The Lake Lothing (Lowestoft) Third Crossing Order 201[*]

Document SCC/LLTC/EX/94: Response to ABP's Deadline 5 and Oral Submissions at 7 & 8 March 2019 Hearings

Author: Suffolk County Council

Date: 15 March 2019

Figure 2 - Extract from Design Report – plan view of rotated section

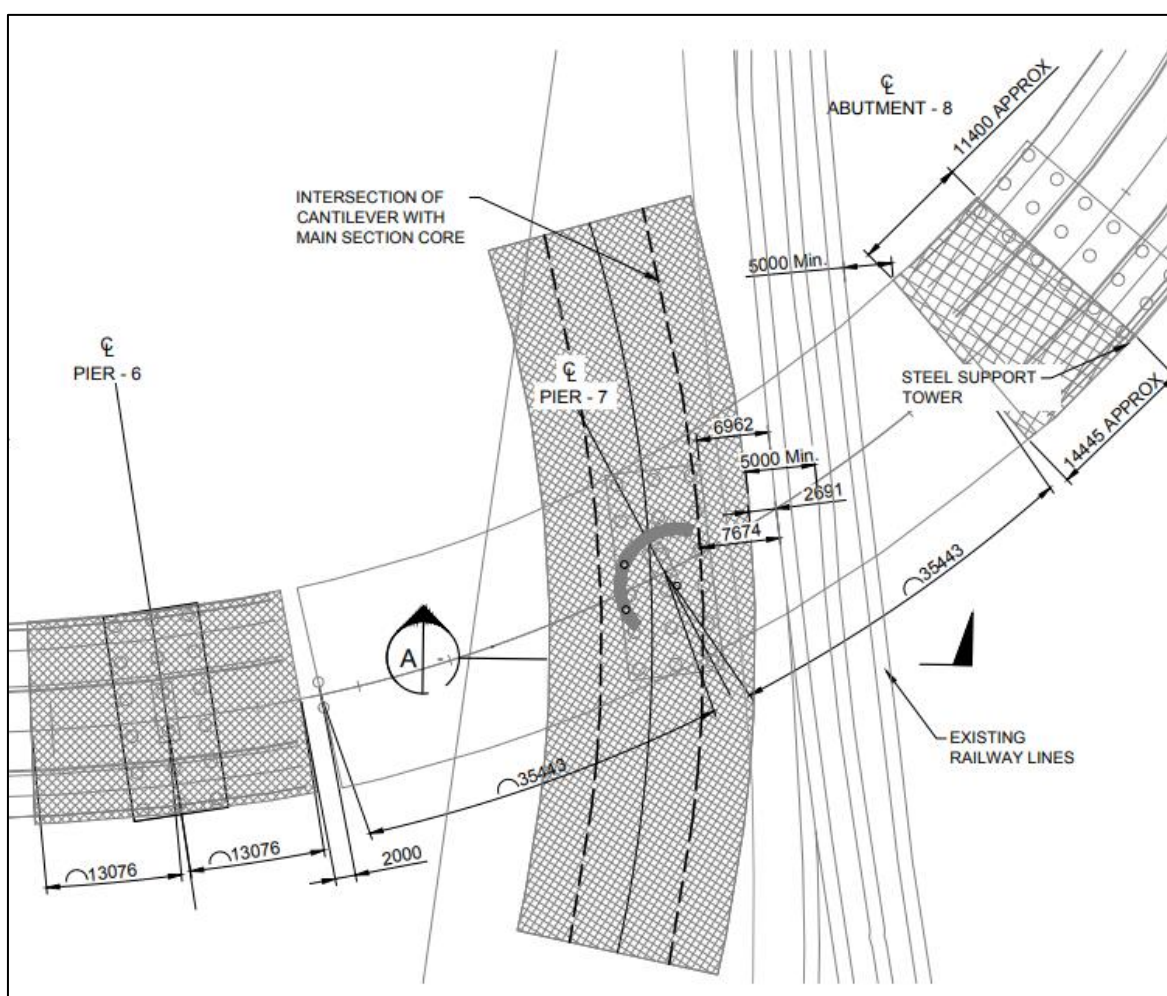
- 1.3.1 Plot 2-20 covers Commercial Road up to the western end of Shed 3. This plot is included because the Applicant is considering a construction methodology that would involve the Network Rail span of the bridge being constructed at right angles to the main alignment (i.e. parallel to Commercial Road) and then being rotated in to place.

- 1.3.2 In this arrangement this span would oversail Commercial Road in the location of plot 2-20, and therefore, after allowing for positioning of cranes, temporary supports, traffic management (to avoid vehicles traveling from the west being 'trapped' behind Shed 3), and appropriate safety clearances, plot 2-20 has been included in the DCO's proposed temporary possession limits.

- 1.3.3 This construction methodology is illustrated in the Design Report Appendix 2 - OAIP for Approach Span (Document Reference 7.5, PINS Reference APP-125). An extract is provided below showing how the span is constructed parallel to the railway tracks on pier number 7, before being rotated in to place. This construction methodology is being considered to minimise the duration of any possession of the railway.

Figure 3 - Extract from Design Report - long section of rotated section

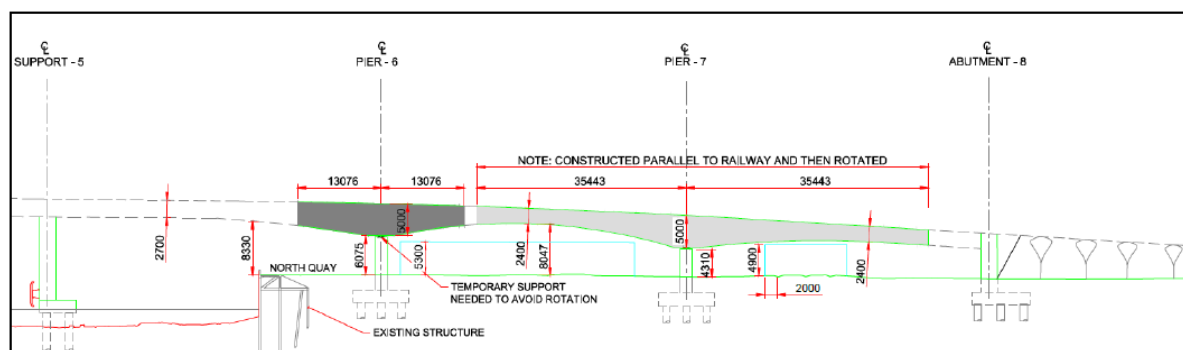
- 1.4.4 An adequately sized compound in this location is critical to an efficient and timely construction programme. As can be seen from the mainline long section sheet 1 of 2 (Document Reference 2.9, PINS Reference APP-040) there is approximately 50m from centre of pier to centre of pier, as such this is the nominal length of beams that will be required for these spans. The deck is approximately 20m wide in this location.

- 1.4.5 It may well be the case that full sections (i.e. sections of deck from pier to pier) are required to be assembled before being lifted in to place in a single lift. In that instance there is therefore a section some 50m long by 20m wide that would first need to be assembled in plot 2-22 and then lifted in to place. There are at least two sections that would need to be assembled/lifted in to place from plot 2-22, those being the sections north and south of pier 6 (refer to Figure 3 above for the position of pier 6).
